MANDATORY SERVICE BULLETIN

No. 2190
ATA Code 52-10

SUBJECT: DOORS - CABIN DOOR LATCHING WARNING PLACARD AND CABIN DOOR ADJUSTMENT INSTRUCTIONS

Cabin Door Latch Points
Figure 1

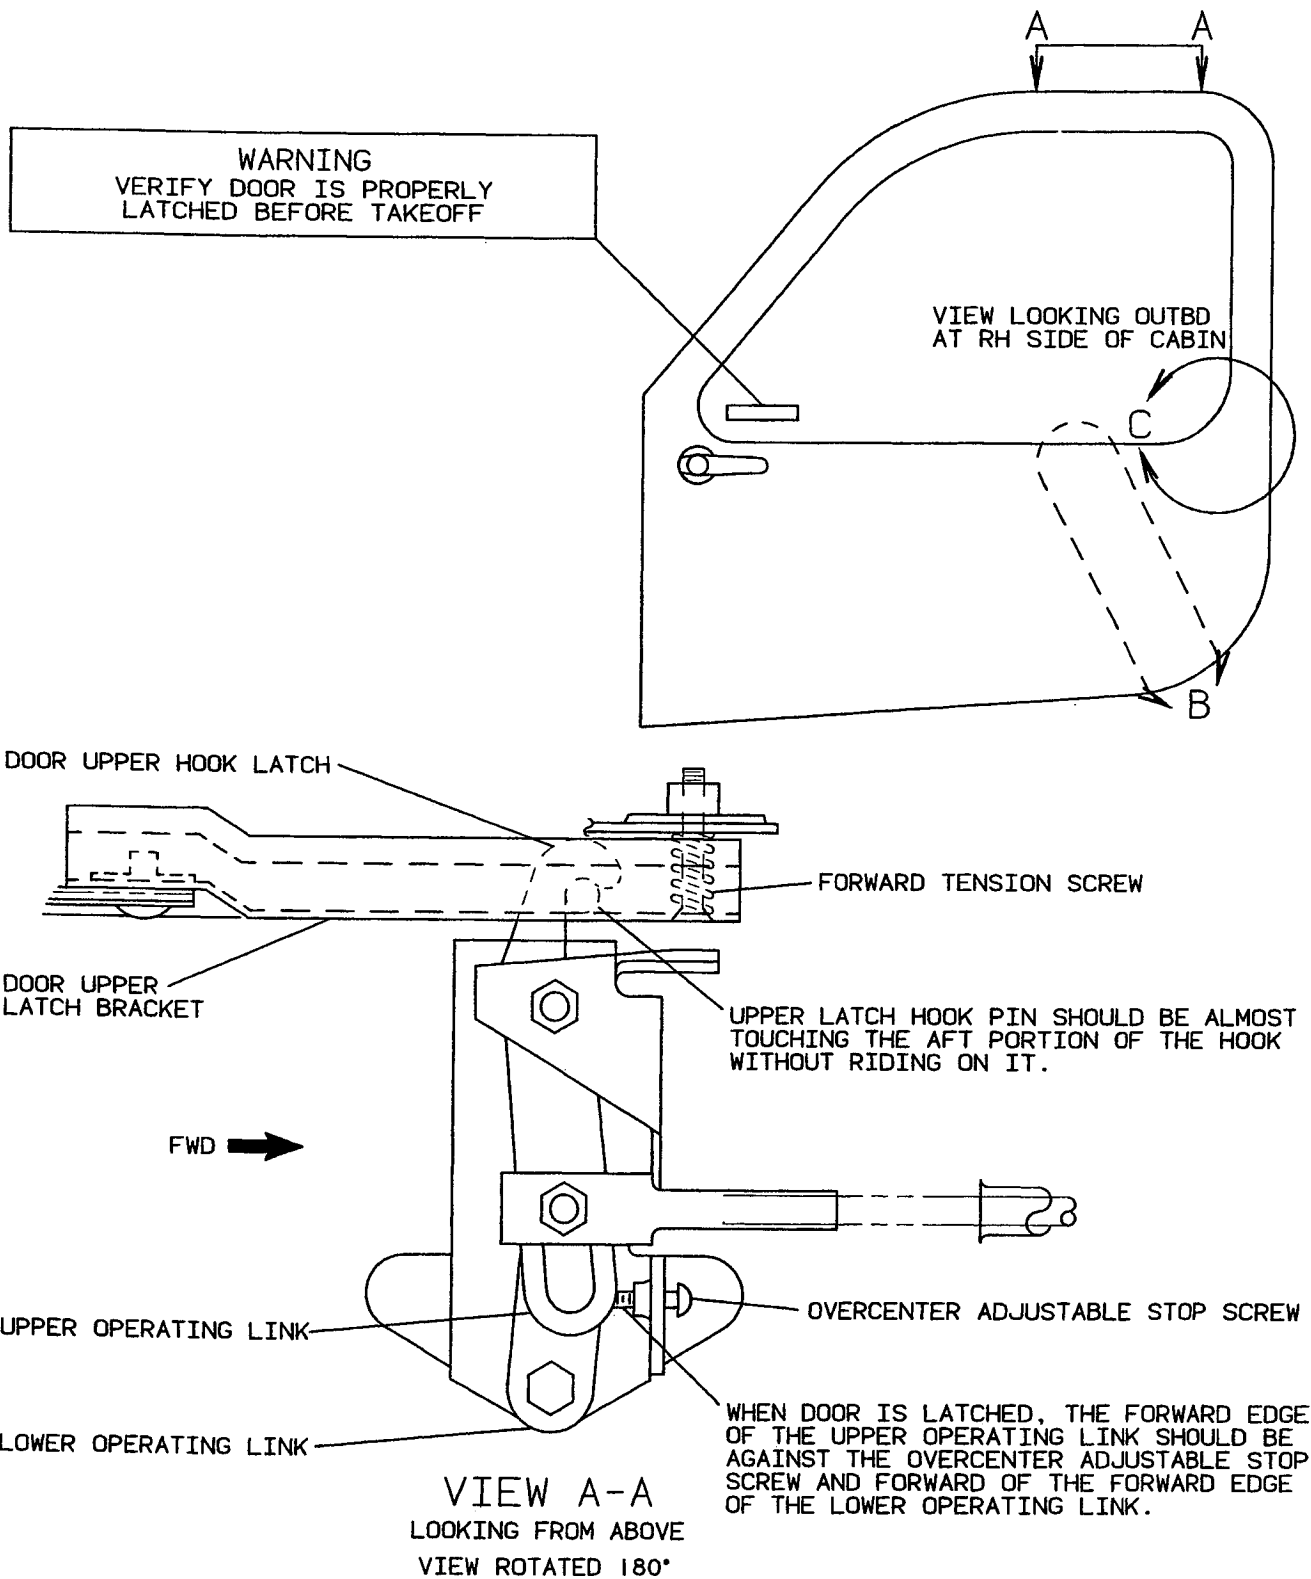
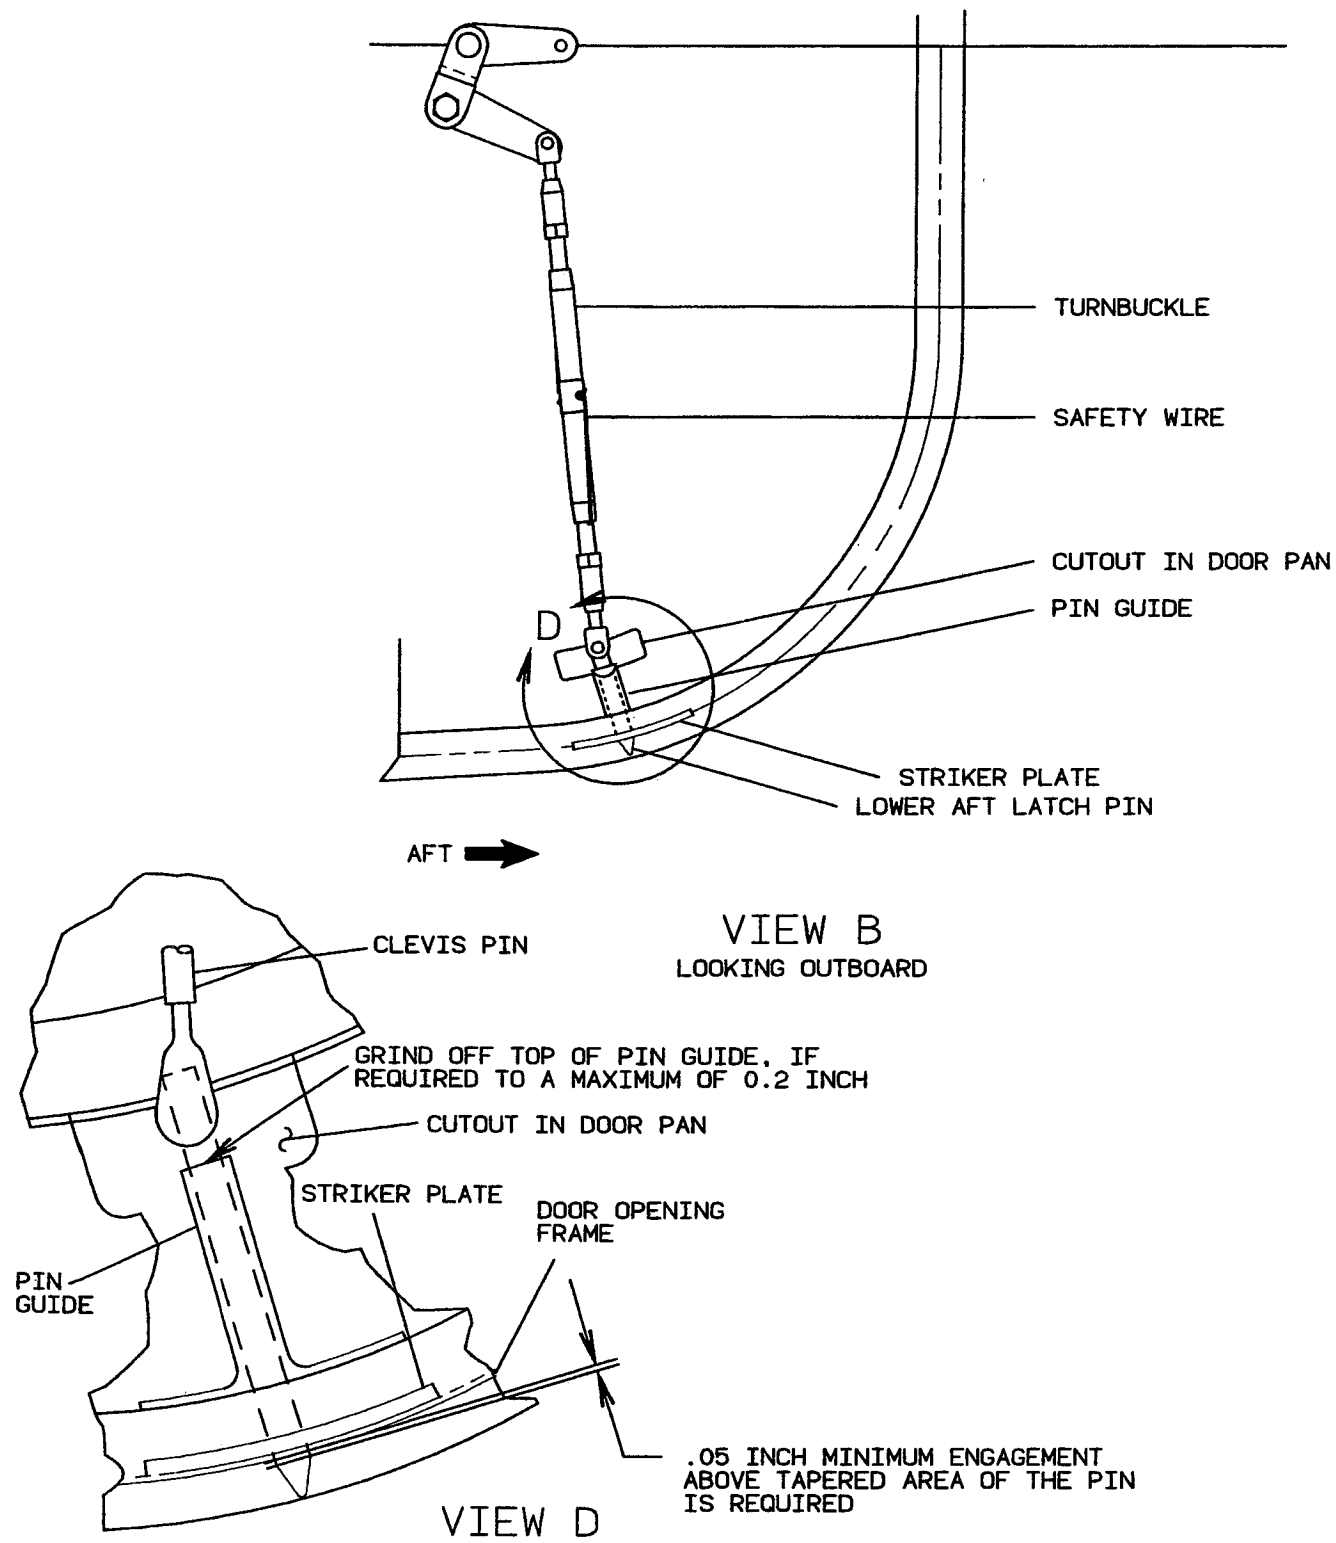
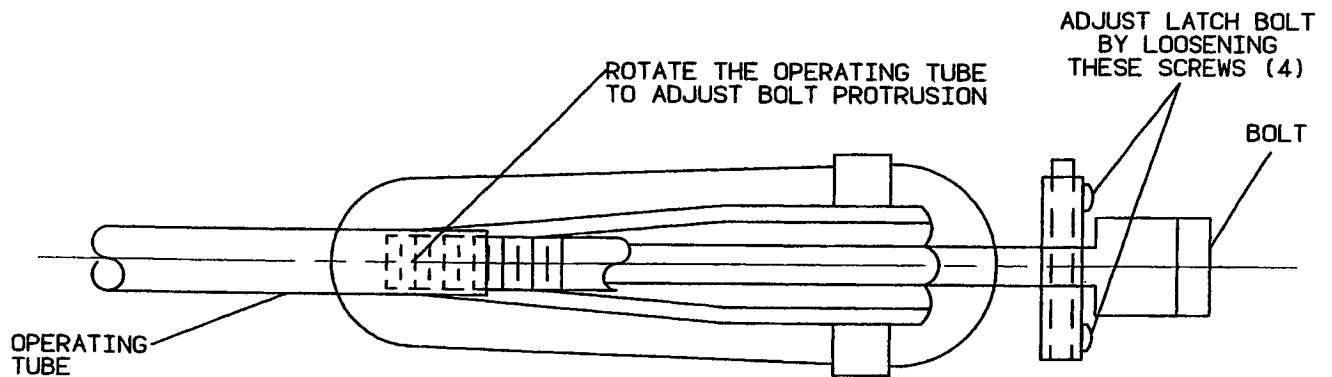
1. Affix the enclosed P/N 36-530166-3 placard to the inside lower forward corner of the door window above the inside door handle as shown in Figure 1.

1) Referring to Figure 1, View A-A, check to ensure that the upper latch mechanism is over center when the door is latched. This can be accomplished by using a small inspection mirror to see that the upper operating link is against the adjustment screw and the forward edge of the upper operating link is forward of the forward edge of the lower operating link. If the latch mechanism is not over center when the door is latched, adjust the overcenter stop screw.

2) Referring to Figure 1, View A-A, check to ensure that the upper latch hook pin is positioned so that it is almost touching the aft portion of the hook, but not riding on the hook. If the upper hook does not properly engage the pin, move the pin forward or aft (it has four positions) to obtain proper adjustment.

between the door and the frame, the upper latch bracket needs to be adjusted "in" to create more tension on the door. This can be accomplished by adjusting the forward tension screw. Refer to Figure 1, View A-A.

It may be necessary to shorten the pin guide by grinding a maximum of 0.2 inch off the top of the pin guide as shown in Figure 1, View D of View B, in order to obtain enough travel to make this adjustment.

c. **AFT LATCH BOLT** - Check to ensure that the aft latch bolt provides a precatch and protrudes into the socket on the aft door frame as far as possible without bottoming out. If adjustment is required, proceed as follows, referring to Figure 1, View C.
